ONE SYDNEY HARBOUR

BARANGAROO

R4A SUPPLEMENTARY DESIGN STATEMENT

June 2019

Proposed Scheme for R4A Terrace Access - Plan

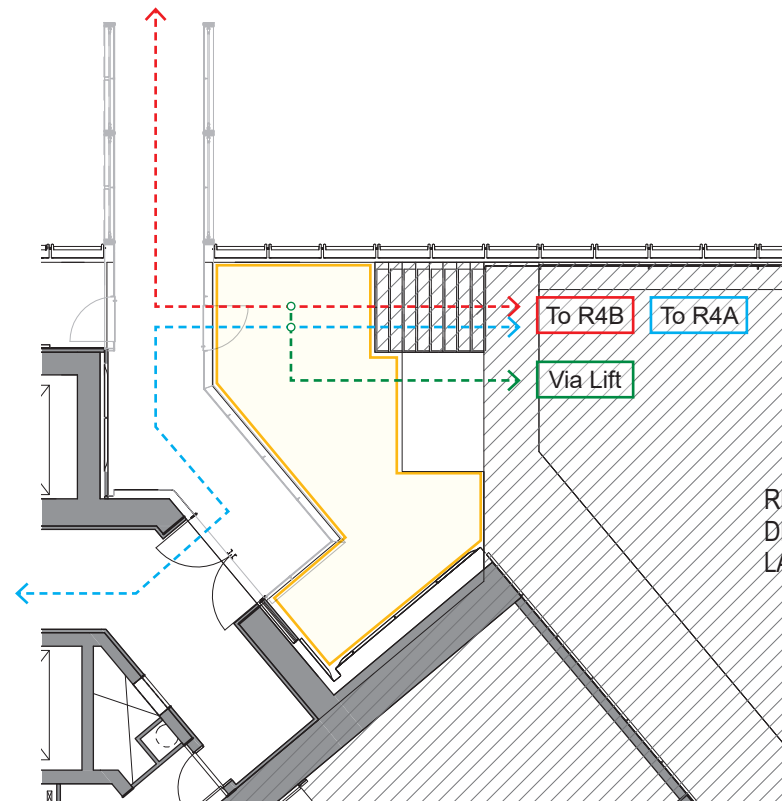
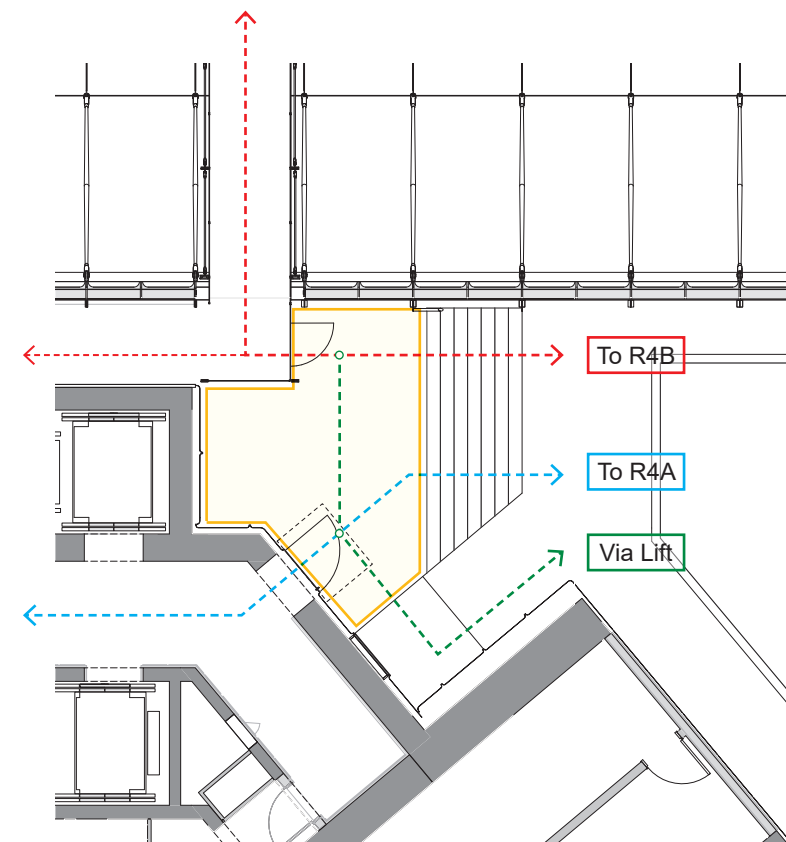
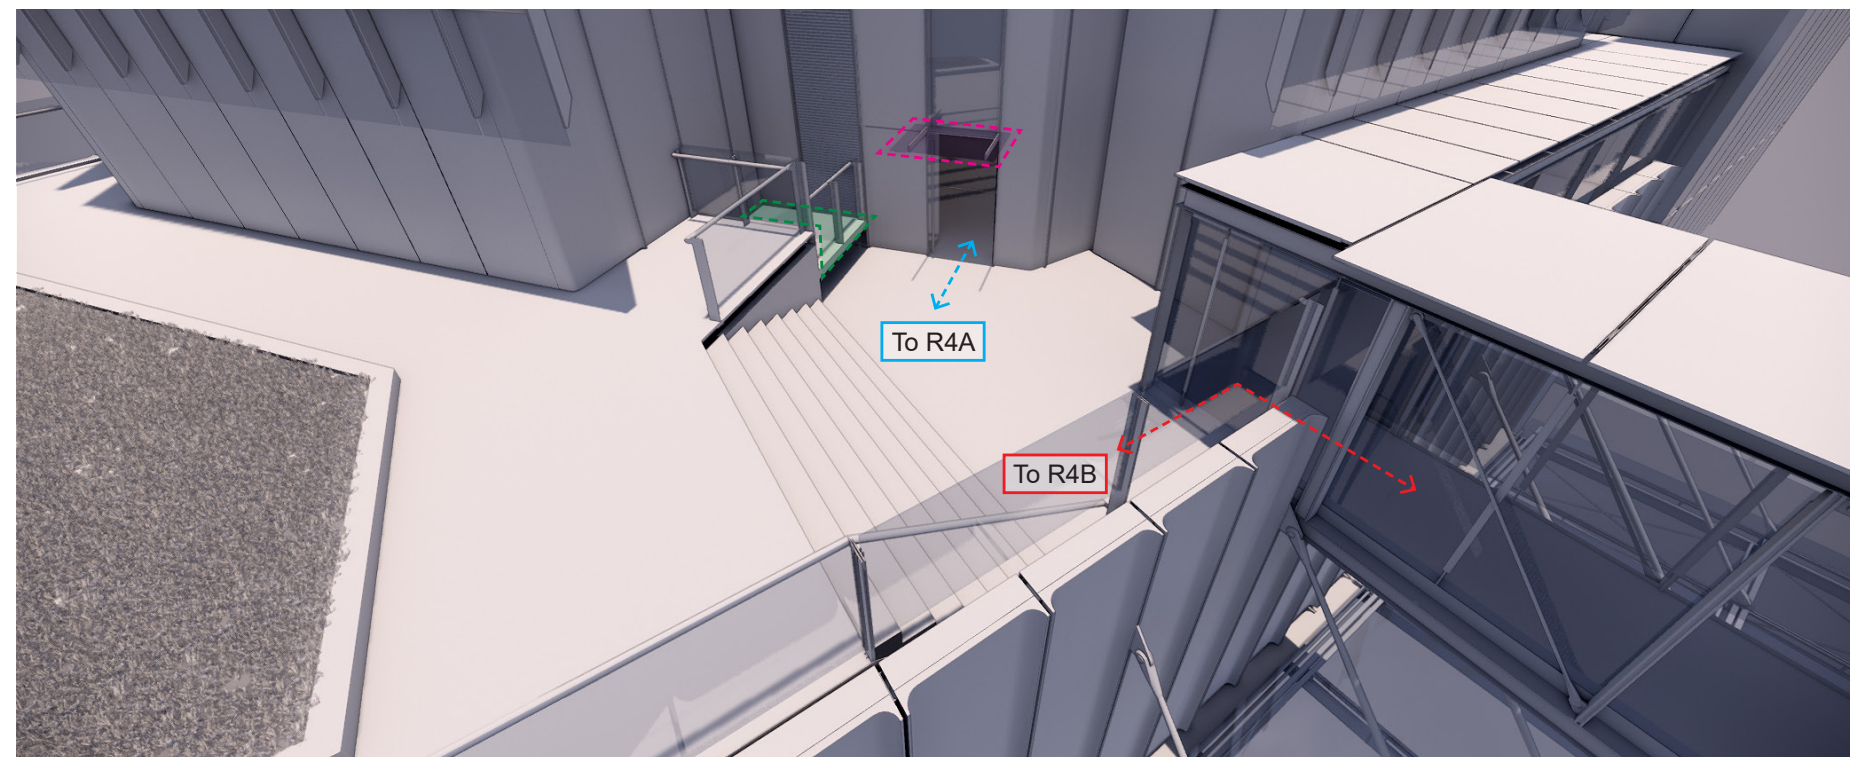
Along with the proposed changes to the connection corridor, the access to the R4A external terrace is also proposed to be amended.

Under the proposed modifications, both door locations leading to the external terrace are retained with one door opening directly to the bridge for users coming from R4B and one opening directly to the R4A amenities corridor. The stairs are repositioned and enlarged as per the adjacent floor plan. This enables the reconfiguration of the residual external space to create an inviting small 'piazza' (highlighted in yellow) that distributes and clarifies the various pedestrian paths.

Since the doorway to the R4A lift lobby would no longer be protected from downdrafts by the bridge connection roof structure, it is deemed necessary to provide a new glazed canopy above this entrance (highlighted in pink in the adjacent 3D view) to act as a windshield. This will ensure the door's proper operability and provide additional amenity for users of this space.
